Technical Bulletin SWEM20-001R2-TB

Subject: How to replace OLED in ICP panel

SWEM20-001R2-TB

We will release a new OLED with a longer life in conjunction with the current discontinued product. This technical memo describes how to replace the old OLED.

KY-692 A Side

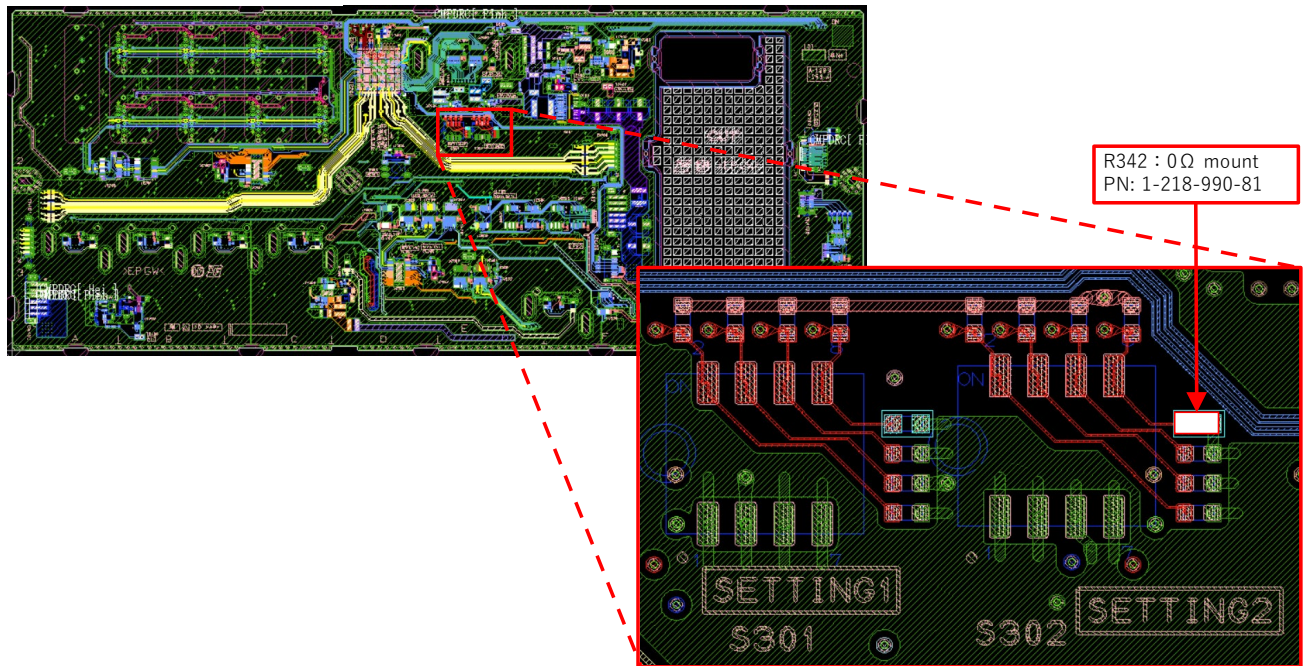
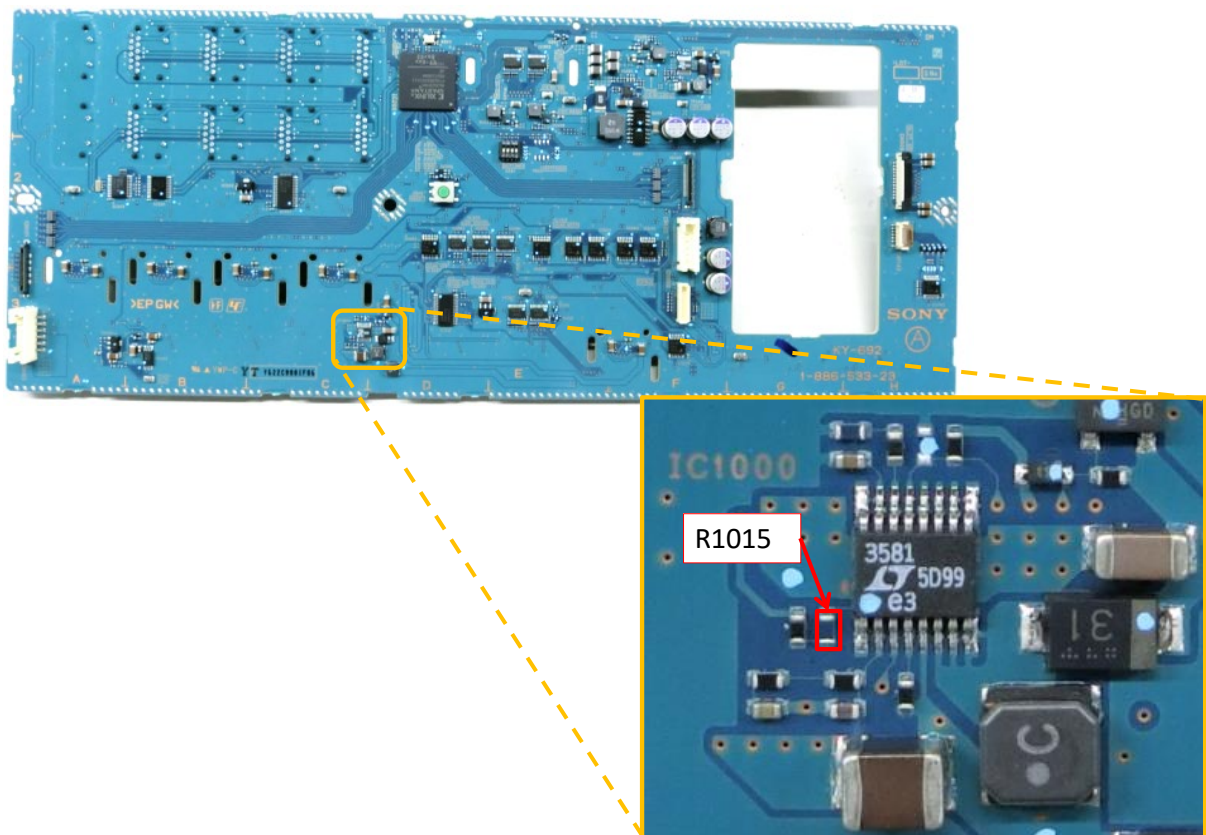
For area S: KY-692

- Mount a 0Ω register on R342. (Set FPGA to new 0.8 inch OLED mode.)

- Remove R1015 and mount a $30k\Omega$ register instead. ($10.4V \Rightarrow 12.0V$)

KY-693 A Side

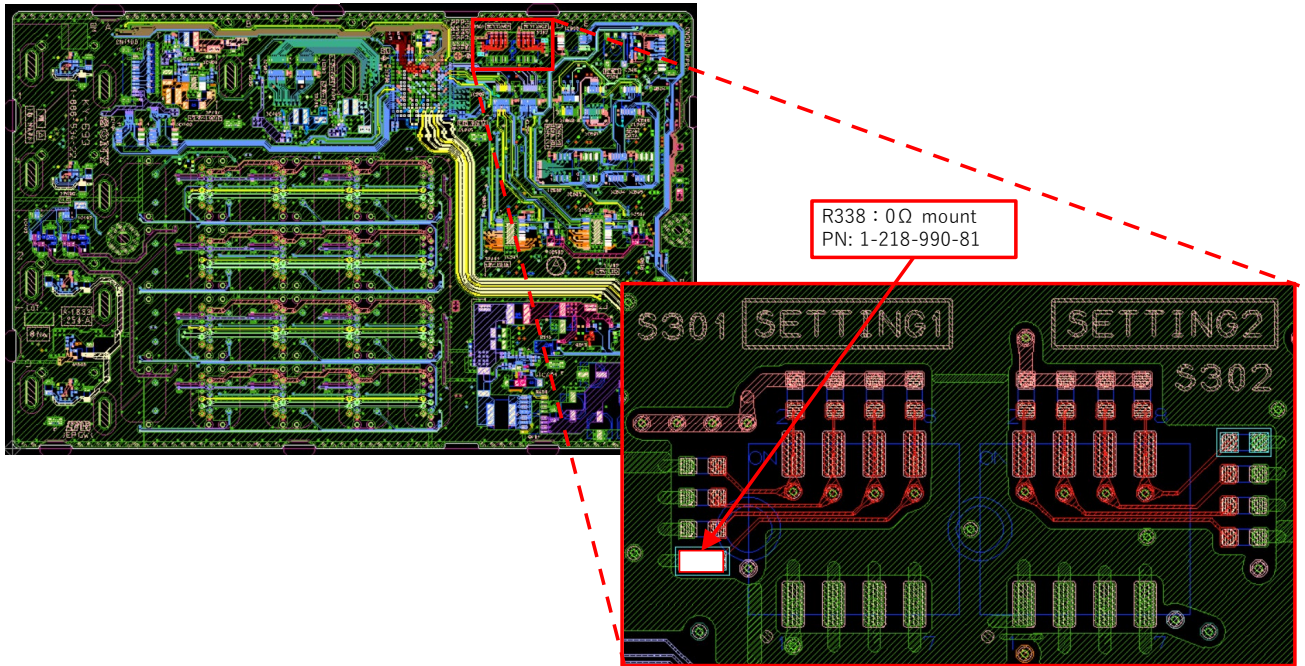
For area T: KY-693

- Mount a 0Ω register on R338. (Set FPGA to new 2.7 inch OLED mode.)

KY-693 A Side

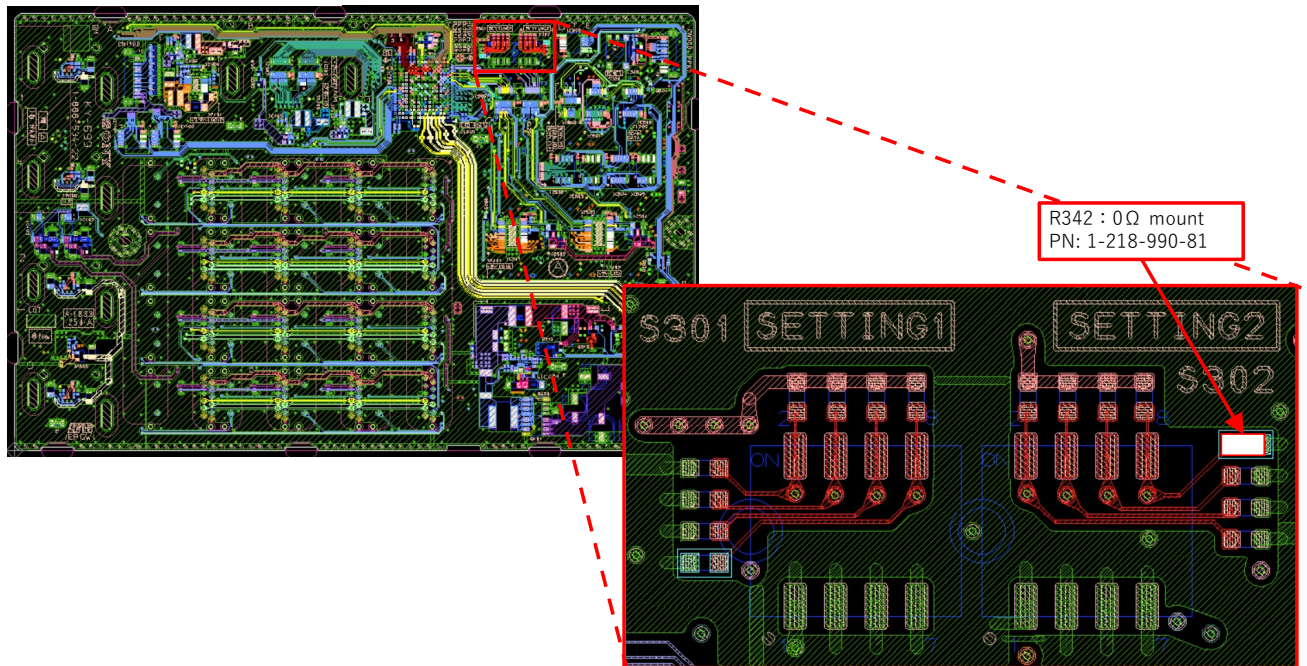
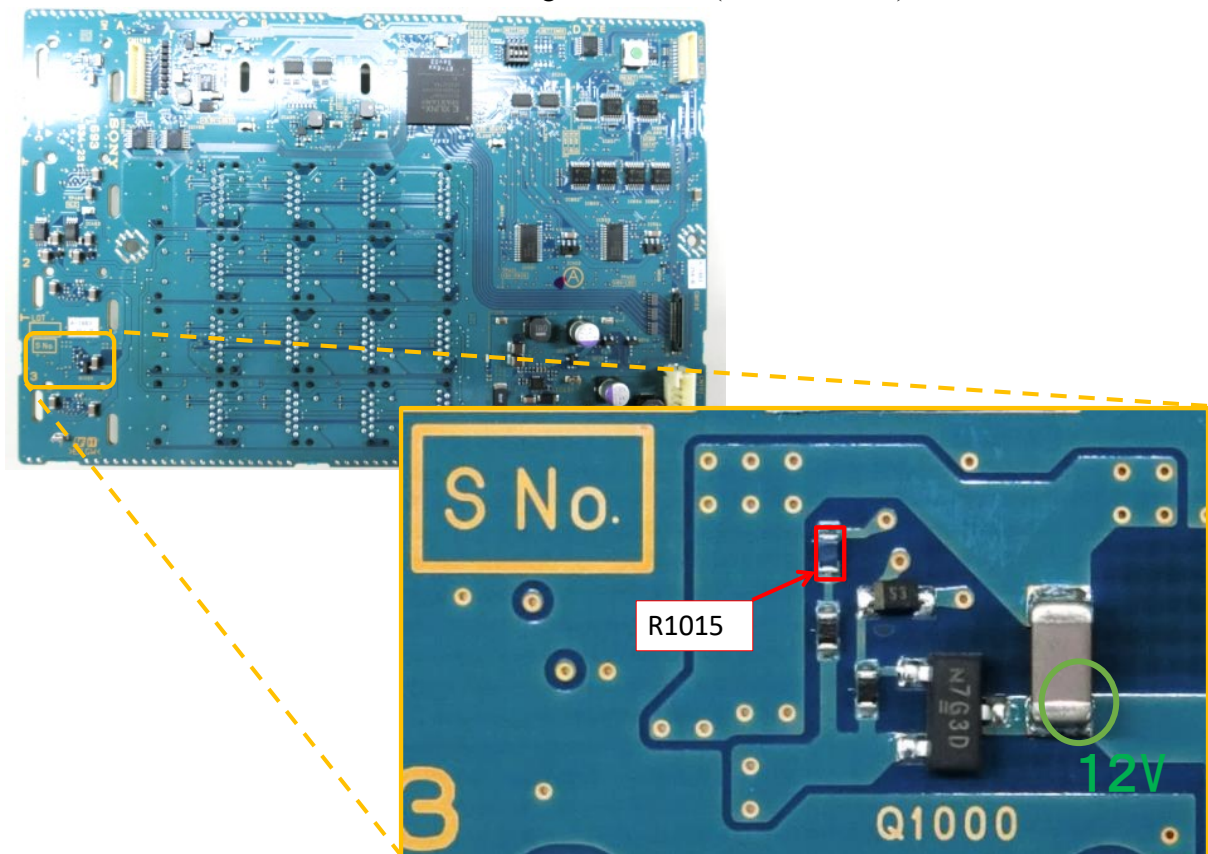
For area U: KY-693

- Mount a 0Ω register on R342. (Set FPGA to new 0.8 inch OLED mode.)

- Remove R1015 and mount a $30k\Omega$ register instead. ($10.4V \Rightarrow 12.0V$)

*If the repair is done correctly, the green part shows the voltage of 12V.

New and old 2.7-inch OLED

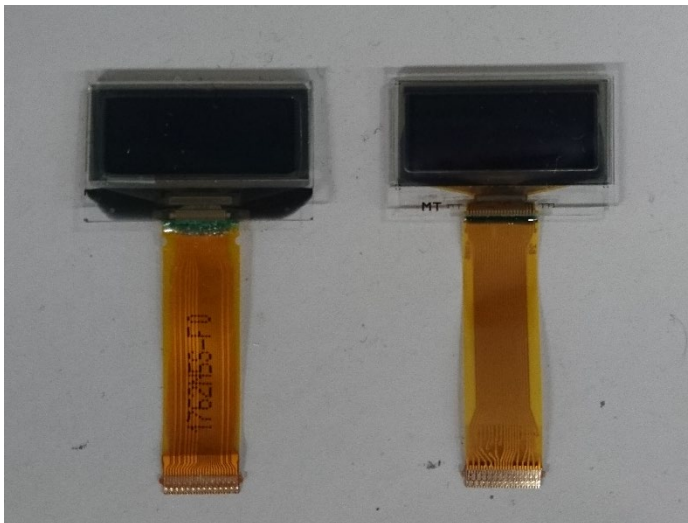
Left: old OLED / Right: new OLED

New and old 0.8-inch OLED

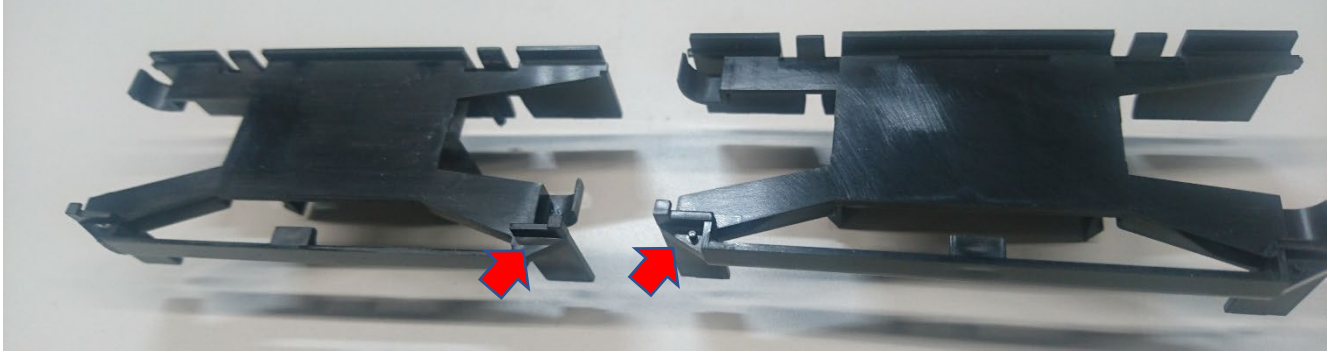
Left: old OLED / Right: new OLED

New and old 2.7-inch holder

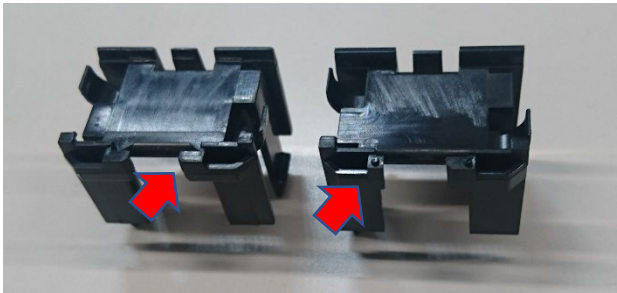
Left: Old 2.7-inch holder / Right: New 2.7-inch holder
